UPGRADING FROM D8R TO D8RE OR D40MZ - 40 GPM SERIES

D8RE / D40MZ Series

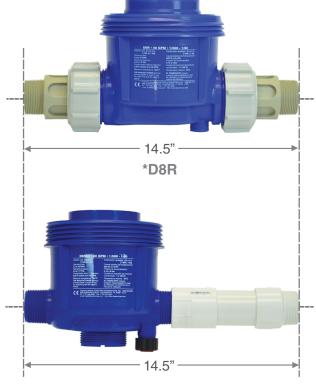
The width on the *D8R and all D8RE / D40MZ Series is different due to the different body styles. There is an easy plumbing option to install your NEW D8RE / D40MZ units to fit in the space of your old *D8R unit

It will require an ADAPTER that consists of:

- A 1.5" slip x 1.5" female NPT Thread Adapter
- B Approximately 4.25" to 4.5" section of 1.5" PVC
- C 1.5" slip x 1.5" male NPT Thread Adapter
- PVC glue

- Glue the piece of pipe B to the slip side of each fitting A and C
- Wrap thread tape onto the threaded part of the injector's body
- Screw the new adapter onto the D8RE / D40MZ Series injector body

Kit Part #: 8P107
